City of
Richmond

Report to Development Permit Panel

File: DP 15-700370

Re: Application by Yamamoto Architecture Inc. for a Development Permit at
9560 Alexandra Road

DRAWING NUMBER:
L1

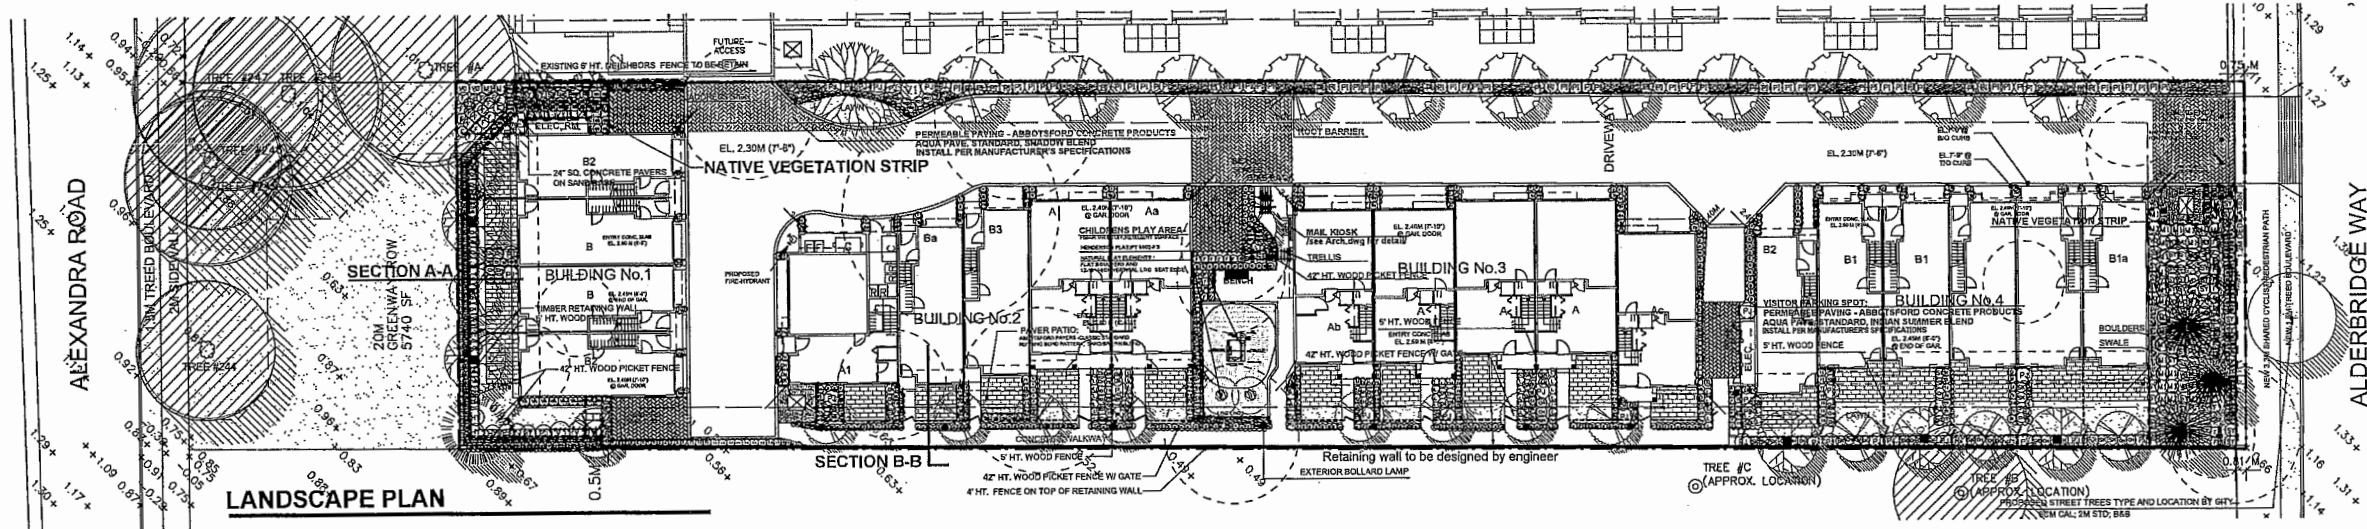
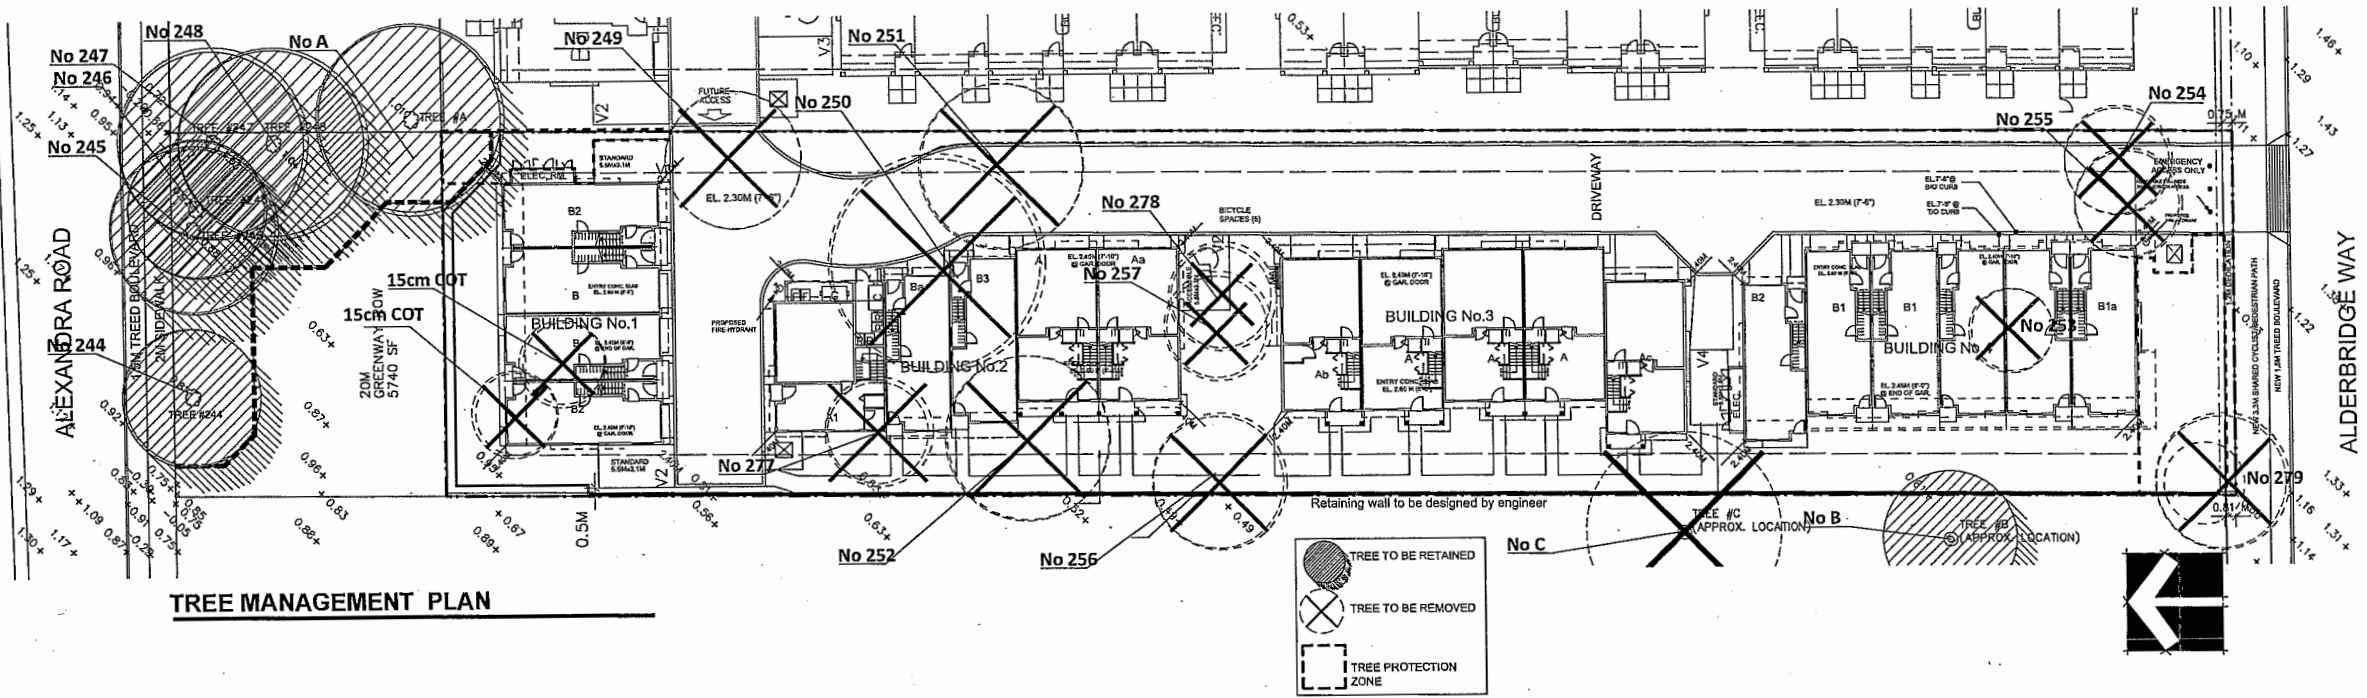
- choice of native plant species is generally good; however, consider replacing the pacific crabapple trees with the more ornamental vine maple trees at the northeast corner of the site; *PMG: Pacific Crabapple trees have been replaced with Vine Maple trees at the northeast corner of the site. Please see L1 for your reference.*

- appreciate the planting along the internal drive aisle; however, ensure that there is adequate root barrier between the road curb and gutter for the red maple trees; *PMG: Root barrier has been added between road curb and gutter for the Red maple trees along internal driveway. Please see L1 for your reference.*

- no need to provide lawns for units in Building Nos. 2 and 3 as the proposed location is shady; lawn spaces for Building No. 4 units could be better utilized for the walkway extension; *PMG: Lawns for units in Building No.2 and 3 have been reduced. Please see L1 for your reference.*

- review the need for shrub planting between the walkway and the fence as the space could be utilized to enlarge the unit yards; *PMG: Shrub planting between the walkway and the fence along West P.L. have been removed and the unit yards have been enlarged . Please see L1 for your reference.*

- appreciate the planting in the Alderbridge Way setback; consider adding more conifers such as Douglas firs; *PMG: More Douglas firs have been proposed in the Alderbridge Way setback. Please see L1 for your reference.*

- appreciate the tree planting along the east side of the proposed development; however, ensure adequate soil volume; and *PMG: There is 3' wide landscape strip on the proposed side and there is a landscape area on the neighbour's development. Please see L1 for your reference.*
- consider introducing a single cedar in the planting areas between unit garages along the internal drive aisle. *PMG: Single cedar have been proposed in planting areas between units garages along the internal drive aisle. Please see L1 for your reference.*

BUILDING NO. 2
WEST ELEVATION

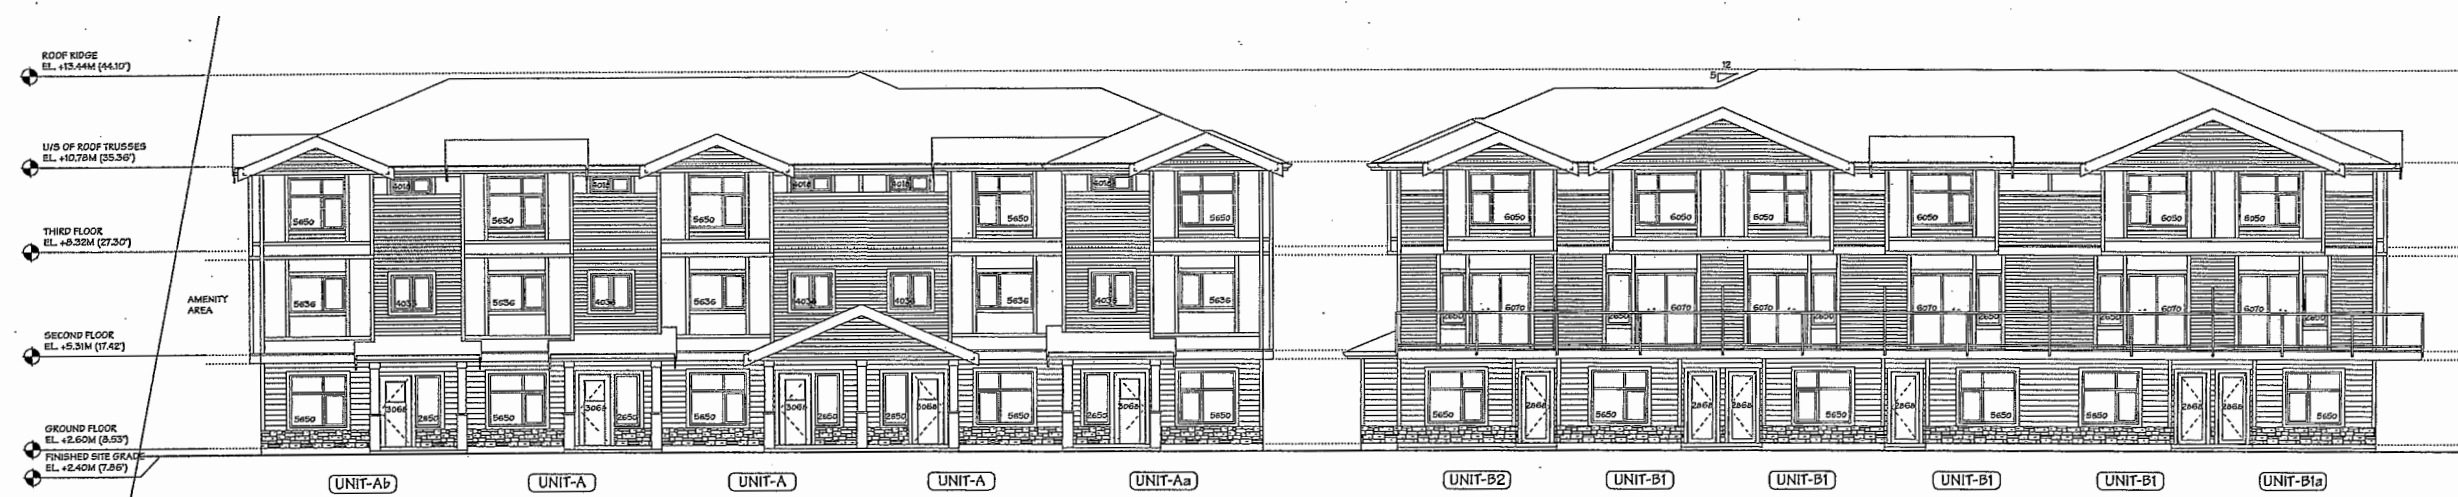
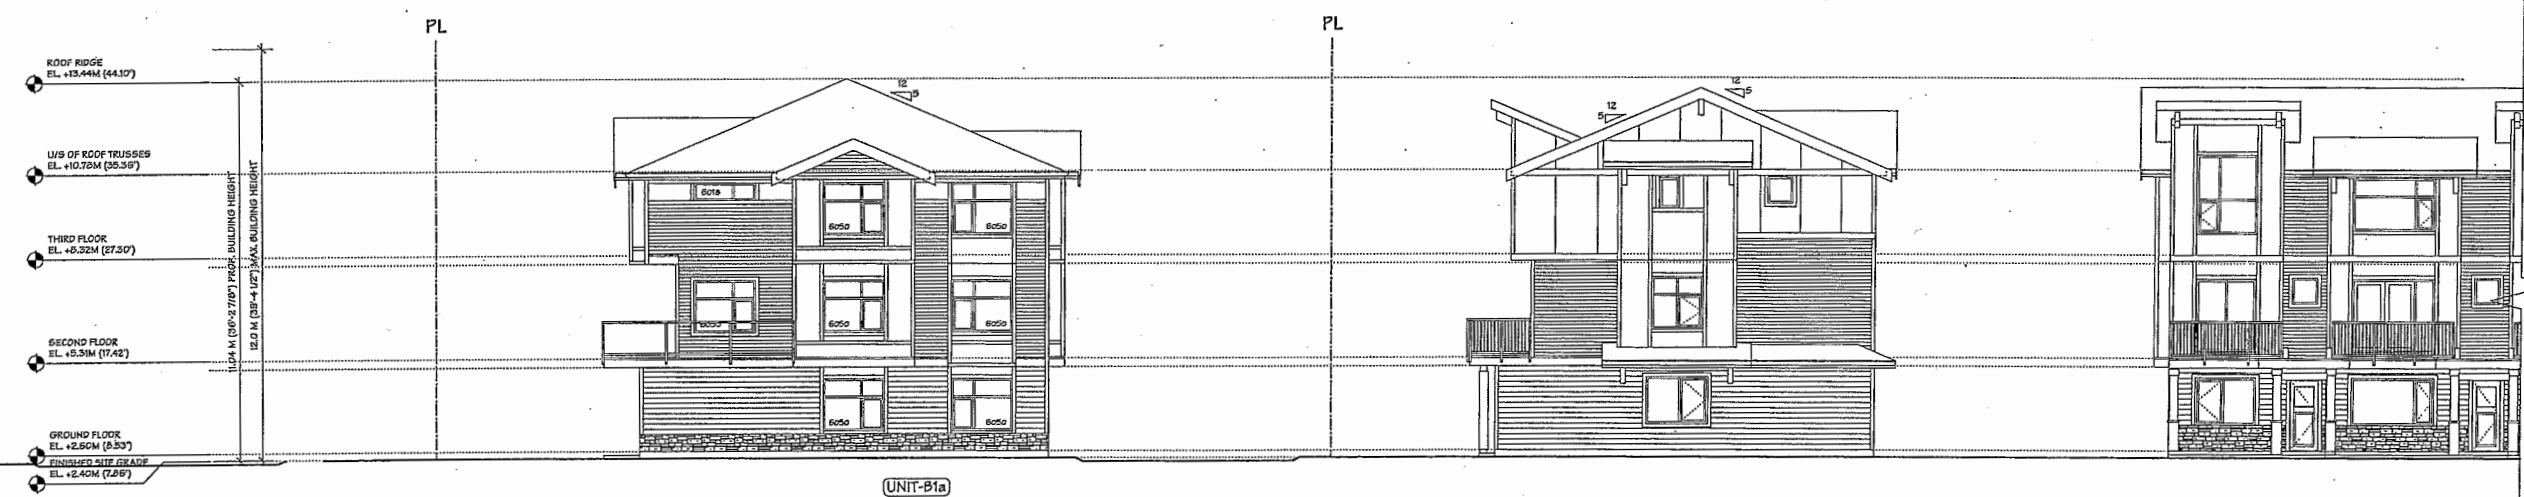
- consider dropping down the architectural element at the top floor of Unit B2a Building No. 1 (west elevation) as it appears heavy on the top; should read like the architectural elements in the upper floors of Building No. 3 units (west elevation); *Elevation revised as per comment.*
